AQUALLIANCE

Re: Vina Subbasin Groundwater Sustainability Plan

These comments on the December 15, 2021 Vina Subbasin Final GSP are being provided to support our recommendation that the California Department of Water Resources and the State Water Resources Control Board find that the GSP is incomplete because of multiple deficiencies and the overall failure of the document to comply with the statutory and regulatory requirements of the SGMA and the Water Code. These comments are supplemental to previous October 17, 2021 comments provided on the Draft Vina Subbasin GSP, which are attached in Vina Final GSP in Appendix 1-F (appendices pdf pp. 107 to 125) and November 11, 2021 comments that were submitted to the GSP and additionally to DWR through the SGMA portal.

Vina Subbasin North Management Area RMS Wells - Appendix 3C AquAlliance Exhibit 1-1

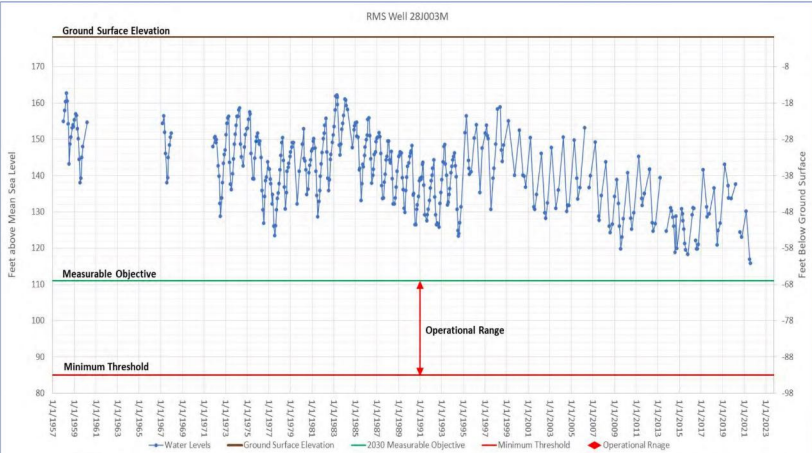
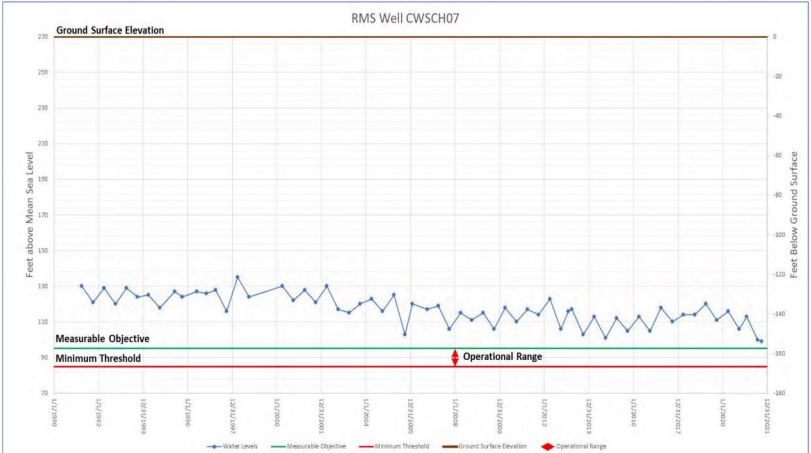
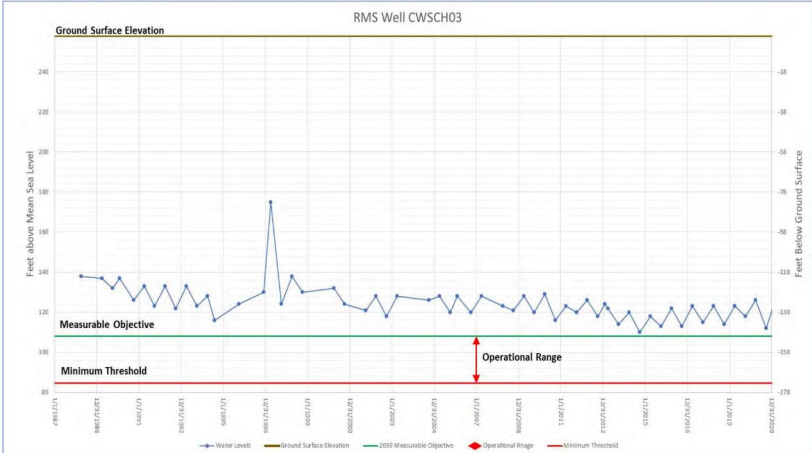
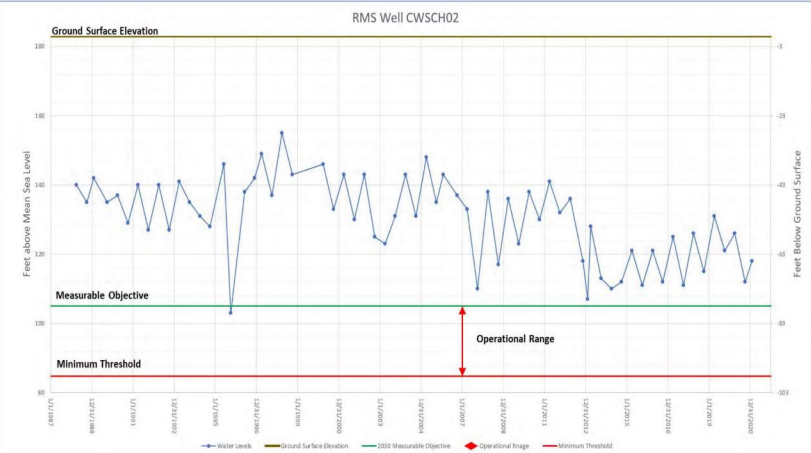
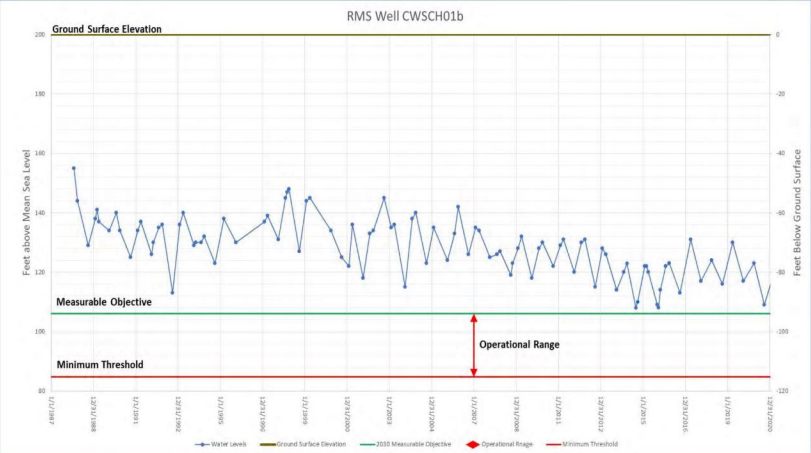
AquAlliance Exhibits 1-1 to 1-3 are compilations of the Appendix 3-C hydrographs for the representative monitoring sites (RMS) groundwater level wells for each of the three Vina Subbasin management areas. These compilations were made to facilitate visual comparisons of the MOs and MTs and historical groundwater levels. A visual analysis of these hydrographs finds that most of the RMS groundwater level wells don't exhibit the downward trend in groundwater levels in recent years that the GSP uses to justify the *...simple non-statistical linear projection to year 2030*. The MO elevations are clearly set at or below the average groundwater levels in recent years, and many are set far below the lowest historical level. The MOs appear to be set at a depth that ranges from 5 to 15 feet below the recent average groundwater levels. This raises a question of validity of the GSP's justification for the MO elevations.

These RMS groundwater level well hydrographs appear to contradict the assumption that groundwater levels are in continual decline. In fact, the Executive Summary in the GSP states that *[g]roundwater storage in the subbasin is relatively stable and changes in groundwater storage reflect groundwater level trends. The Sacramento River and streams that cross the Vina Subbasin stabilize storage volumes by providing recharge to the Vina Subbasin. Between 2000 and 2018, groundwater storage in the Vina Subbasin decreased annually approximately 0.07% from a total of 16 million acre-feet, which calculates to a total of approximately 212,800 af over 19 years. The Executive Summary then states that ...it is highly unlikely that the Vina Subbasin will experience conditions under which the volume of stored groundwater poses a concern. However, the depth to access that groundwater across the Vina Subbasin does pose a concern (p. ES-8, pdf 27).*

The reasoning for setting the MO elevations below the historical groundwater levels even for RMS wells that have a slight downward project misrepresents the baseline condition of the subbasin groundwater levels as evidenced in the RMS well hydrographs (AquAlliance Exhibits 1-1 to 1-3). **The Vina Subbasin MOs should be raised to a level that is consistent with the current groundwater conditions in the subbasin, not the conditions that would occur without any sustainability management.**

Vina Subbasin
Average Change in Groundwater Storage During Drought Years

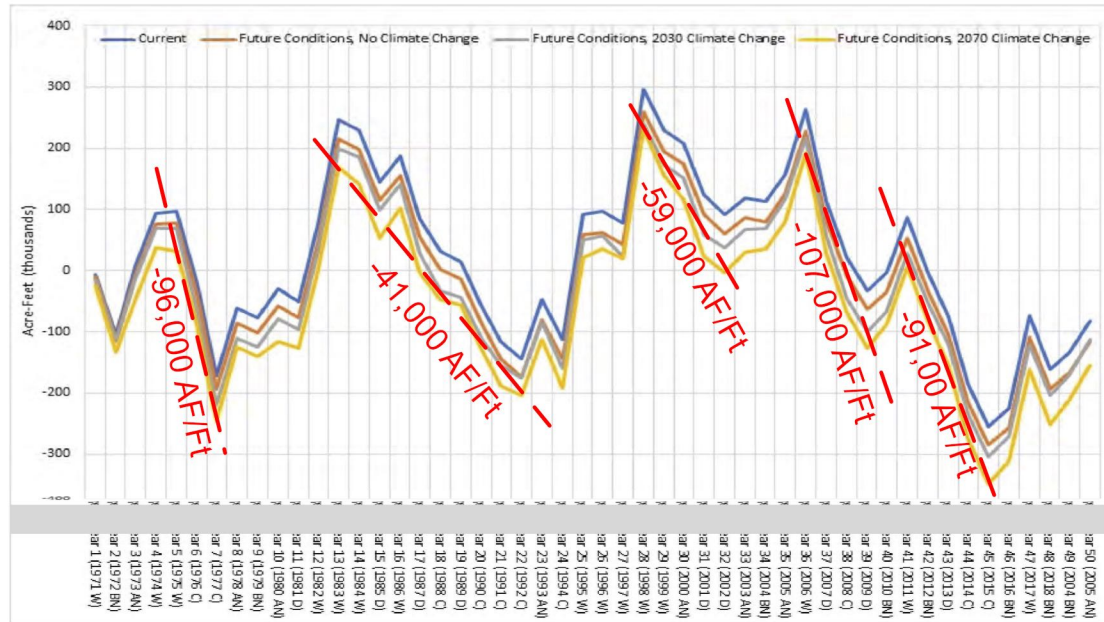
The total basin-wide change in volume when groundwater levels decline from the MOs to the MTs is approximately -637,784 af. AquAlliance Exhibit 3 is a modification of Figure 2-43 (p. 137, pdf 177), which shows the simulated changes in groundwater storage for the Current and future 2030 and 2070 scenarios. Overlain on this graph are lines that give an estimate of the average slope of the annual change in storage during 2070 scenario drought years. The 2070 scenario drought years' changes in storage range from -41,000 afy to -107,000 afy with an average of -78,800 afy.

Using the average change in storage for 2070 scenario drought years of -78,800 afy and the total MOF storage volume of 637,784 af, the Vina GSP will allow groundwater levels to decline for 8 continuous years before the MTs are reached (AquAlliance Exhibit 2). An unreasonable result from the decline in groundwater levels won't be declared for another two years or more because of the definition of an MT (p. 145, pdf 185). When combined with the Historical baseline loss in groundwater storage since the year 2000 of 372,400 af, the Vina GSP will apparently **allow a loss of groundwater storage, and the associated decline in groundwater levels, of over 1-million acre feet before a significant and unreasonable reduction of groundwater storage triggers the need to declare an undesirable result** (372,000 afy + 637,784 afy = 1,009,784 af).

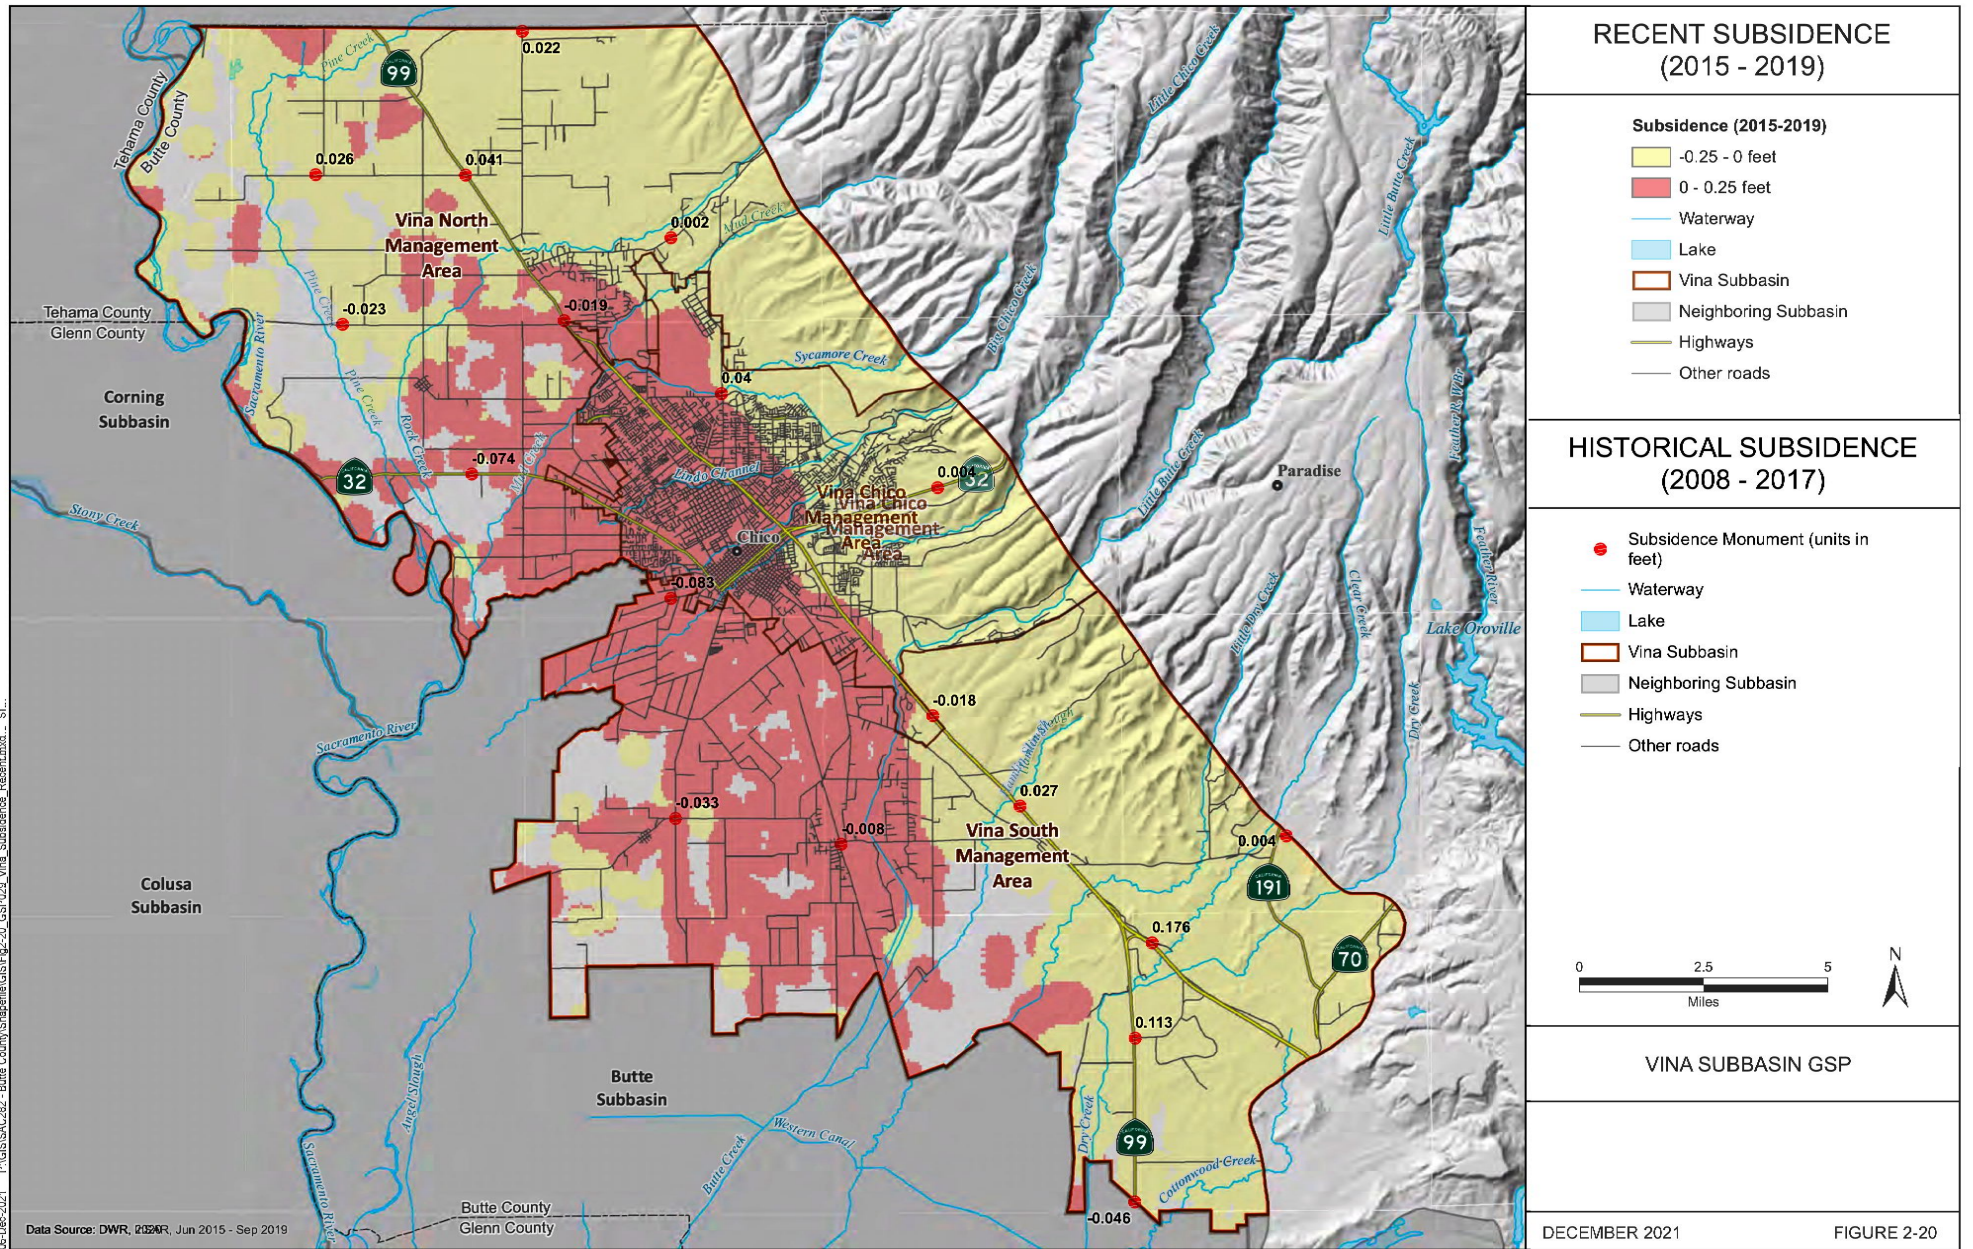
12. The Vina GSP identified only salinity as a Contaminant of Concern (COC) for the subbasin (Section 3.5, pp. 151 through 154, pdf 191 through 194). The plan does identify the locations of historical and current contaminant cleanup sites and lists contaminants at nine active cleanups (Section 2.2.4.2 and Figure 2-18, pp. 86 through 89, pdf 126 through 129). The sources of the contaminants are mostly solvents from dry cleaners and metal manufacturing, with some underground fuel storage and landfills. The GSP fails to discuss the long-term nitrate problems in and around the City of Chico. The Vina GSP water quality RMS well network is made of 8 wells (Tables 4-7 and 4-8, and Figure 4-6, pp. 185 and 187, pdf 225 and 227). AquAlliance Exhibit 6 is a composite of the contaminant map Figure 2-18 overlain with the Vina RMS water quality well locations in Figure 4-6.
